ADDENDUM NO. ONE
NCSB -FBMS

To the Plans and Specifications for:
Nassau County School Board – Project No. 98110-031
Fernandina Beach Middle School Kitchen / Dining Remodeling and Campus
Renovations/Enhancements

Date: October 15, 2018

BUILDING O2 DEMOLITION & NEW LIGHTING PLANS	DATE
	9-25-2018
	D.B.
	LMC
	C.B.
	LMC
	JOB NO.
	18016

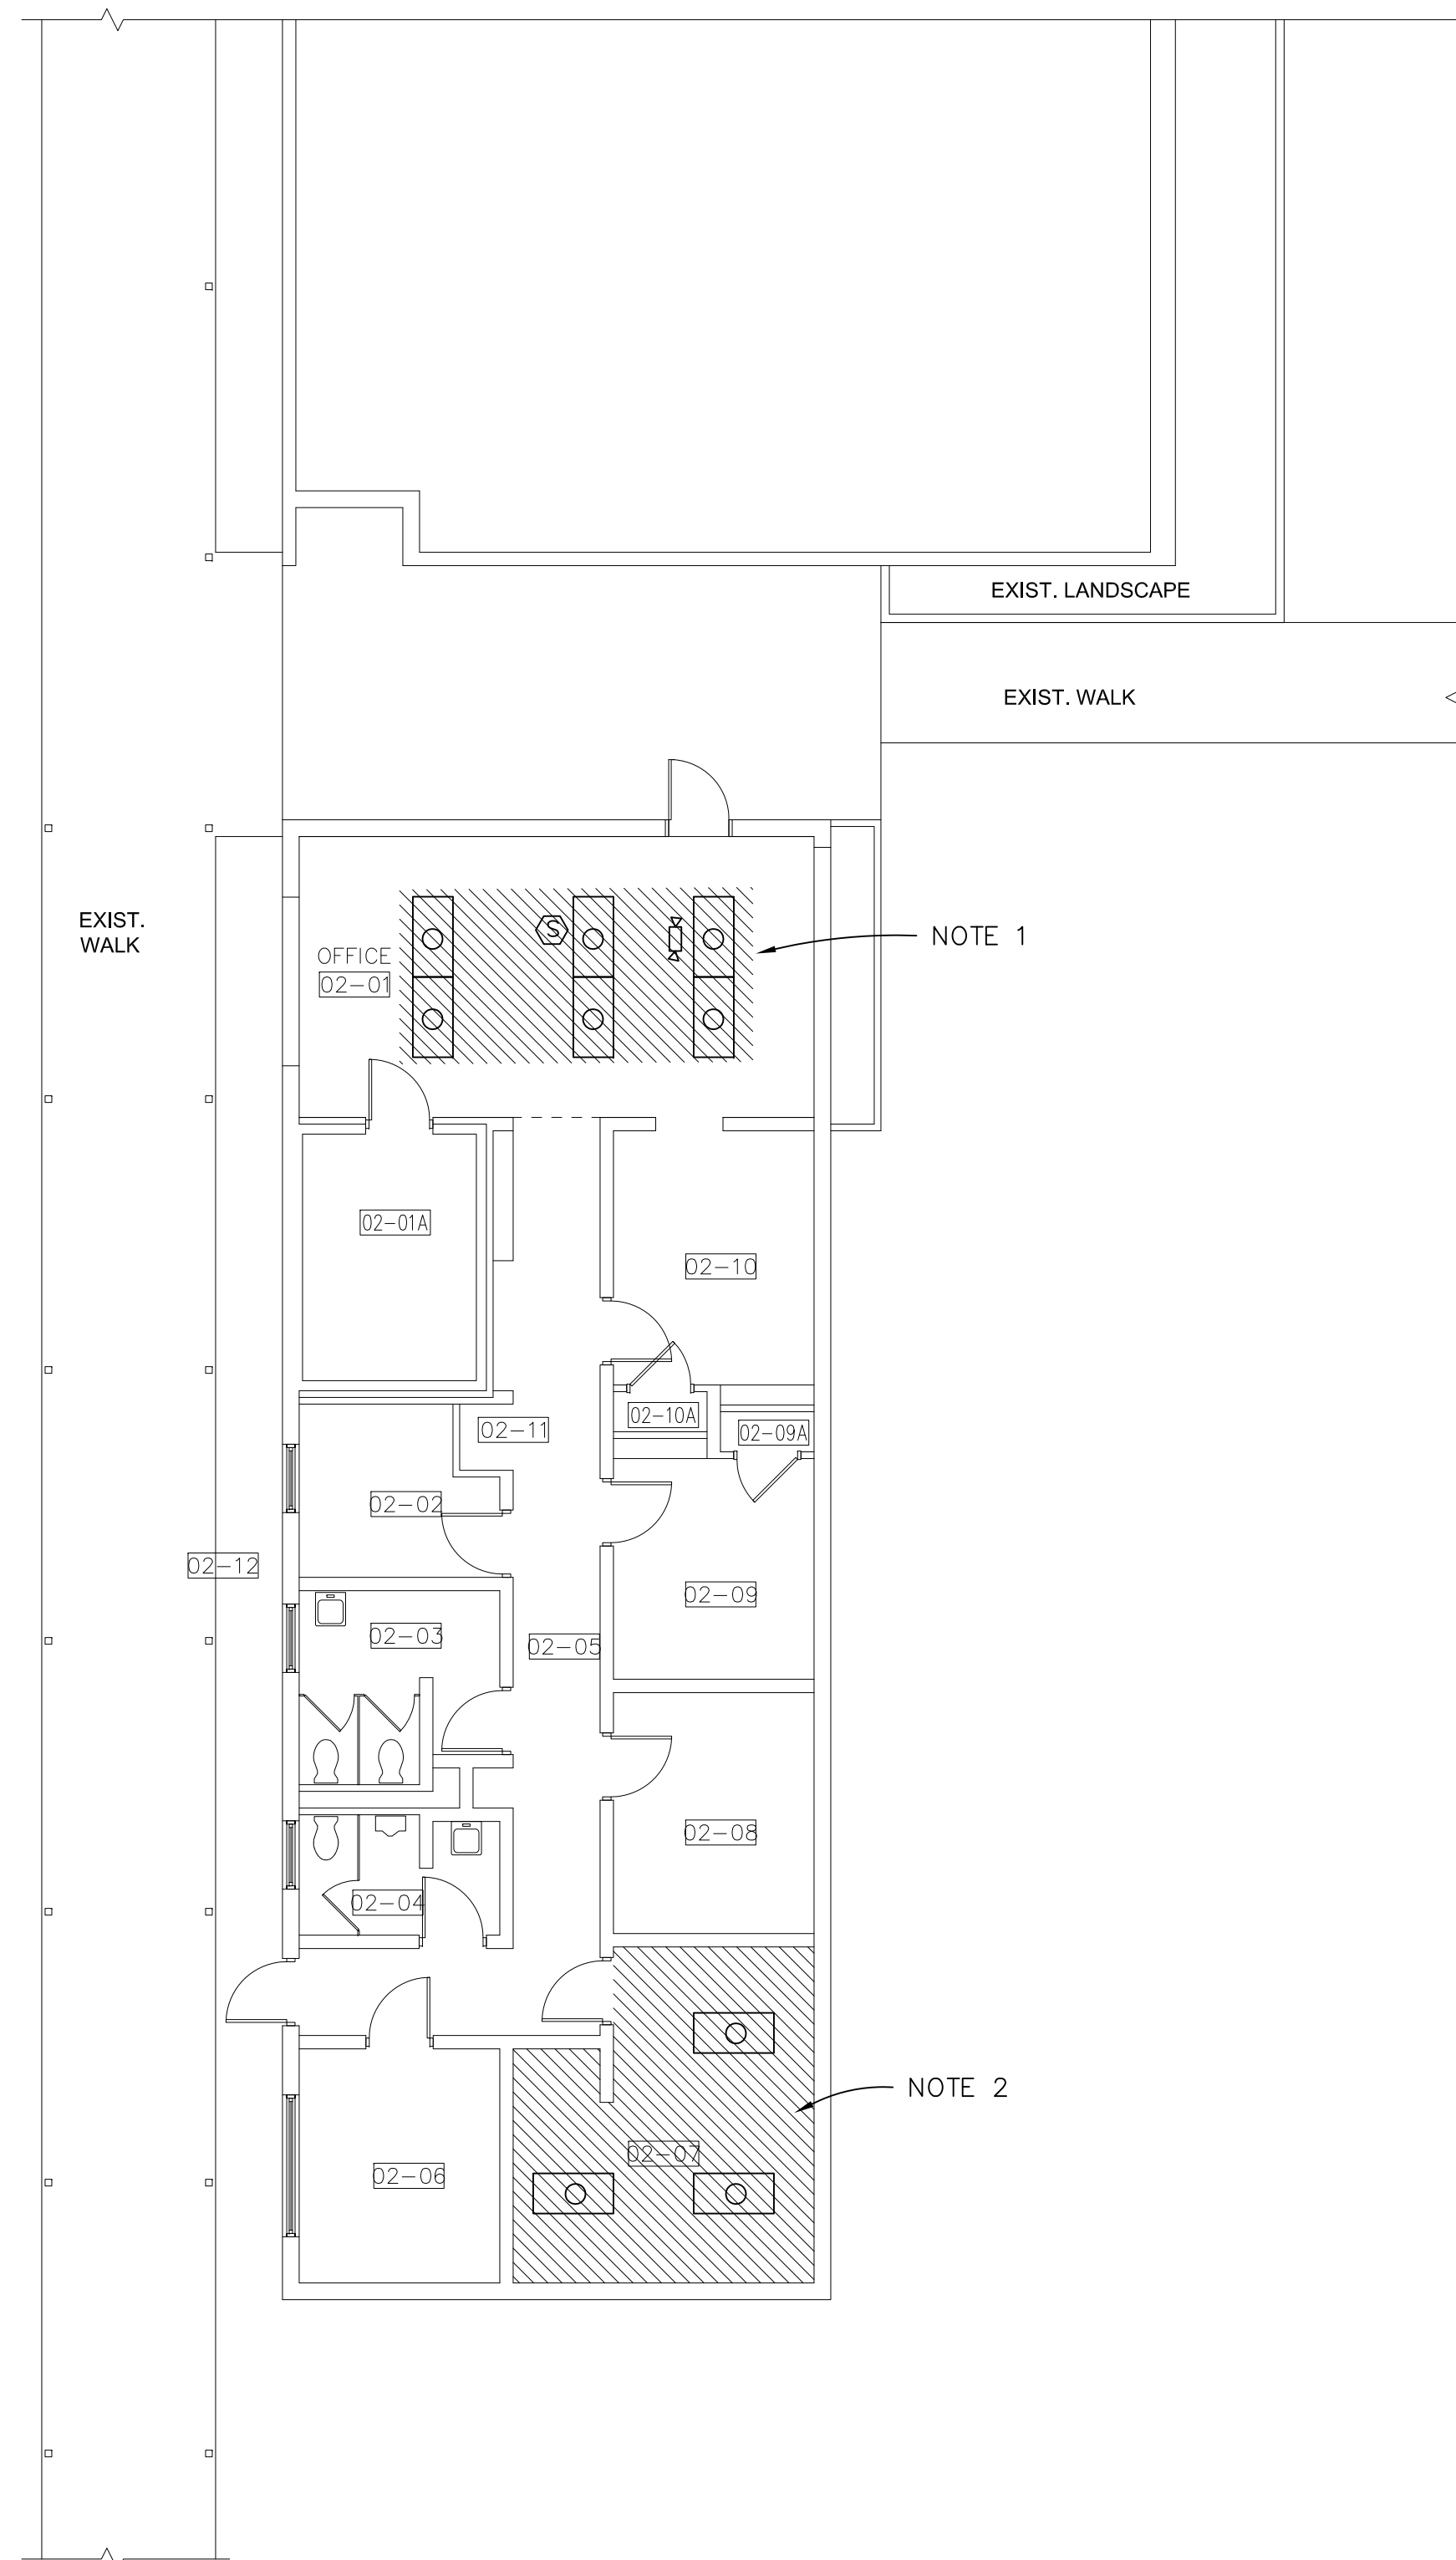
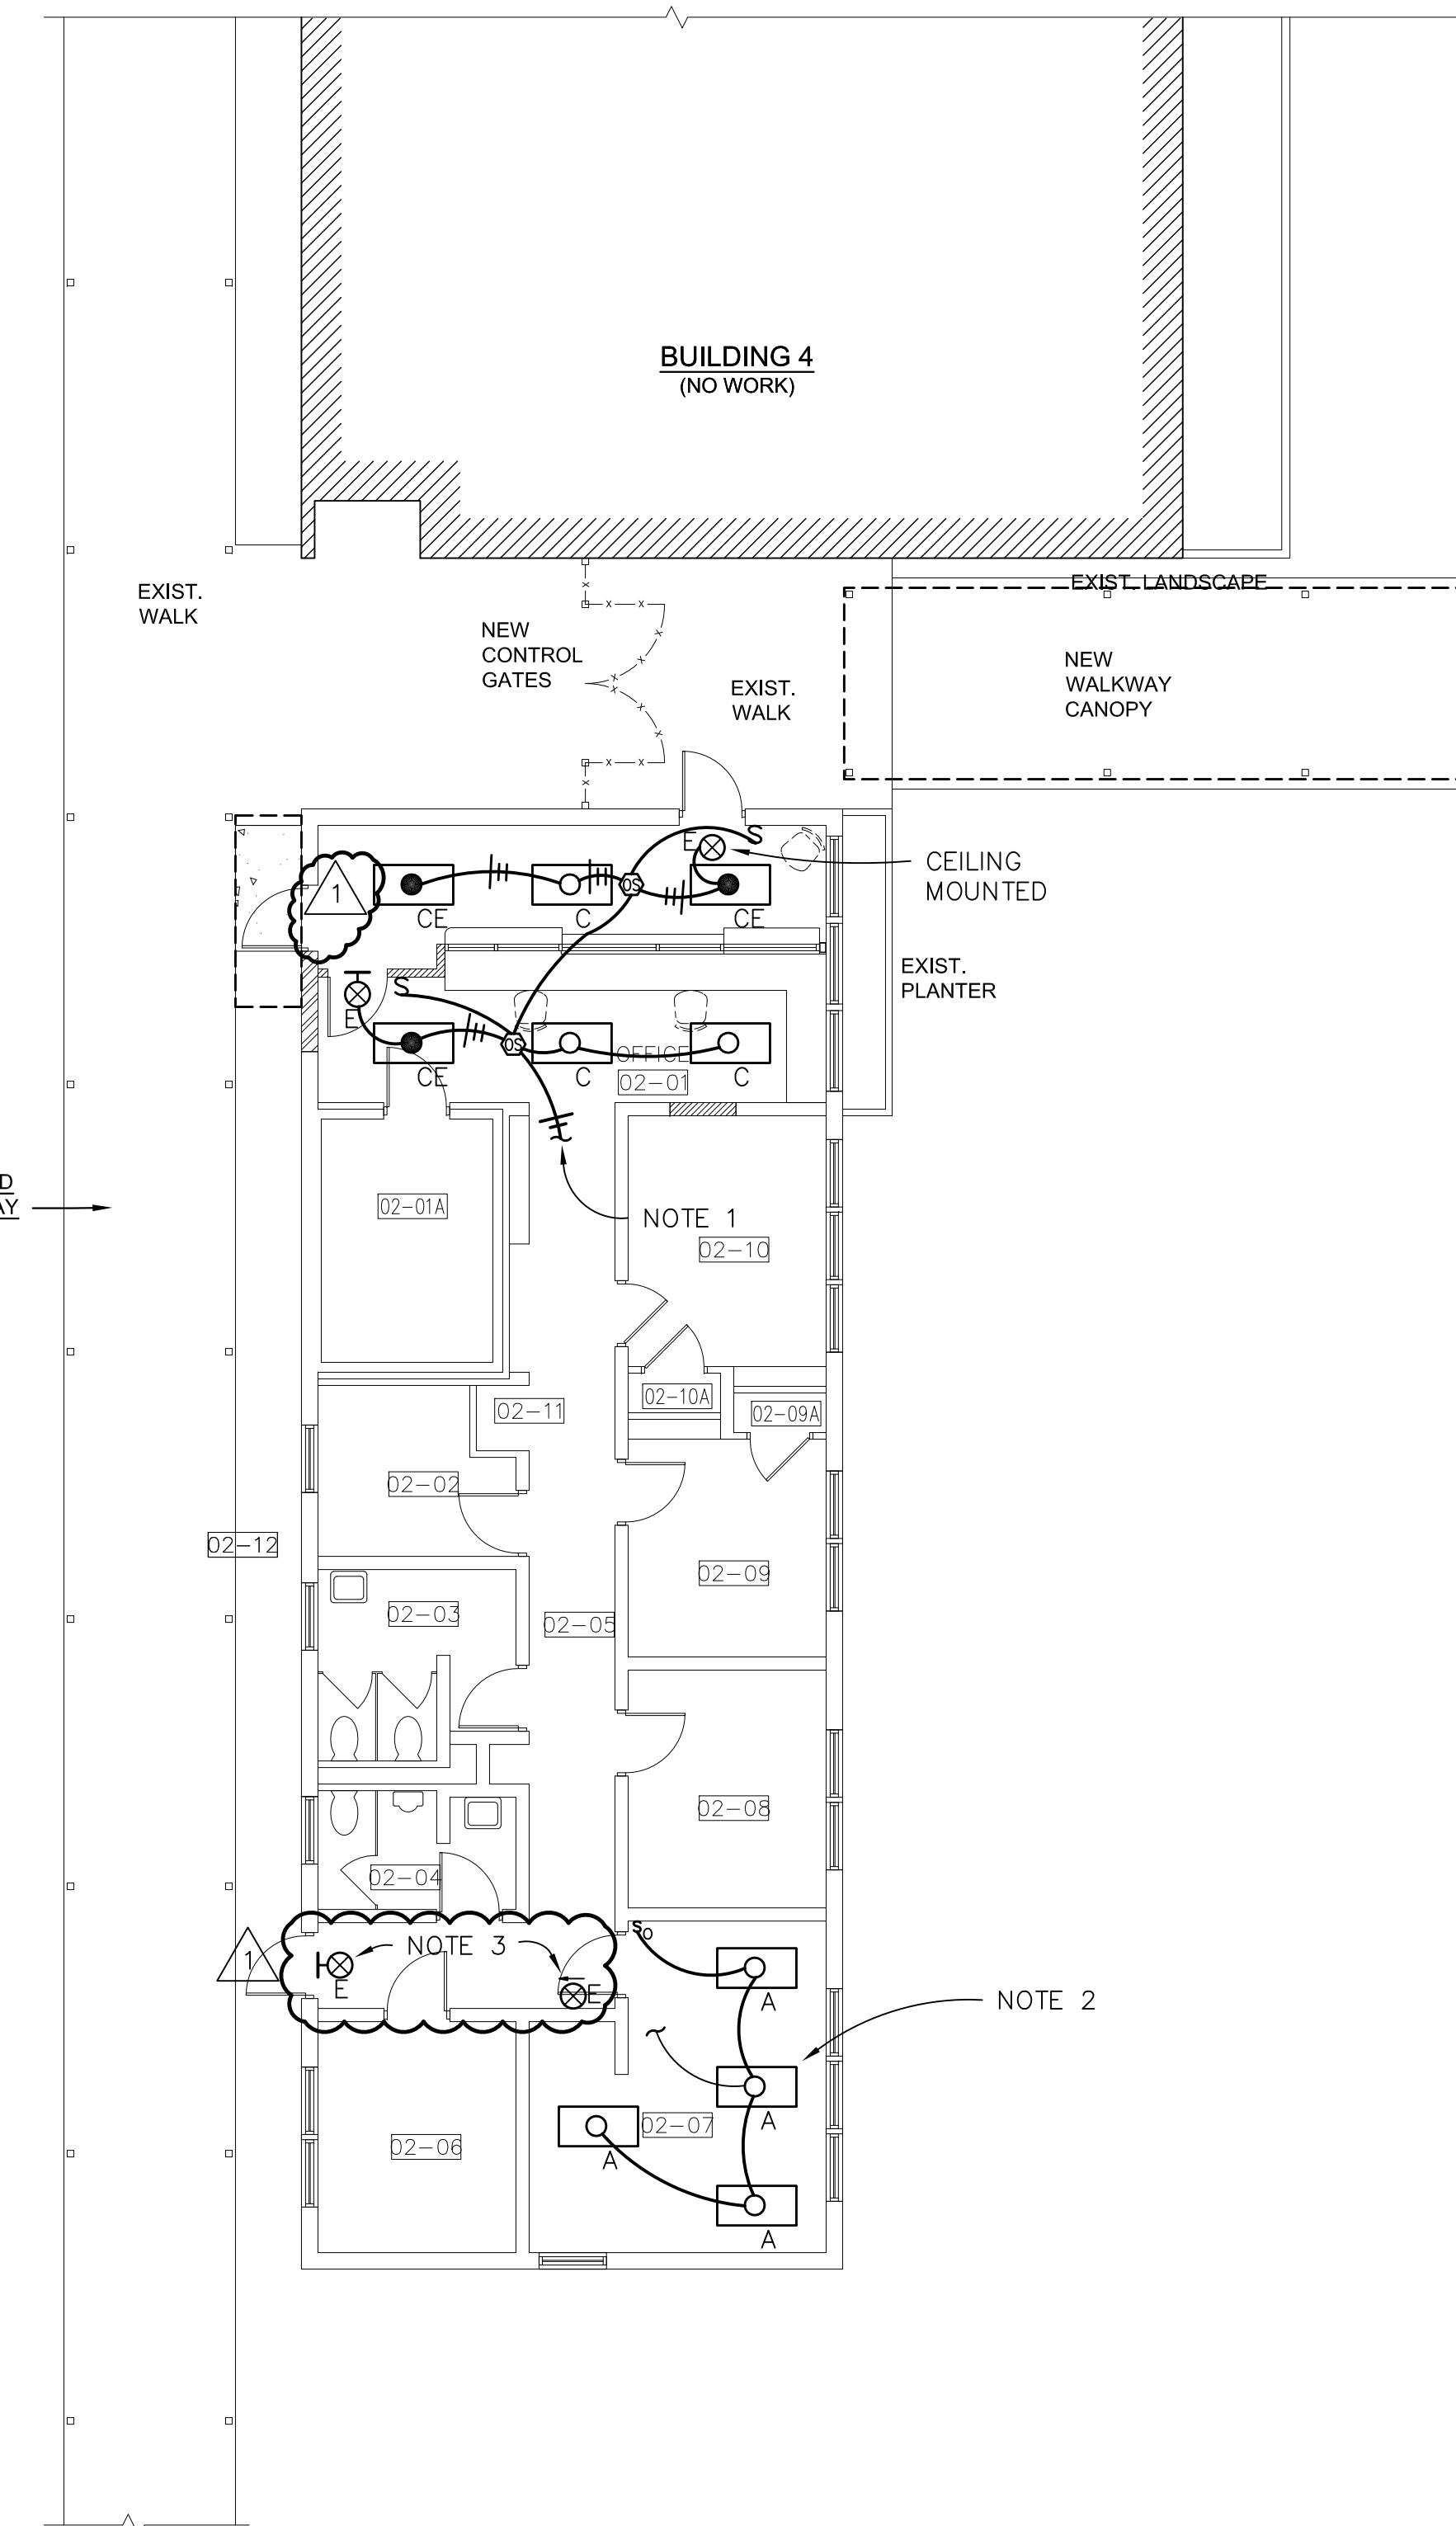
- a. Delete existing Drawing and insert attached new Drawing dated October 15, 2018.
- b. Delete exit light fixture in room 02-01.
- c. Add exit light fixtures at south end of corridor.
- d. See new Note 3.
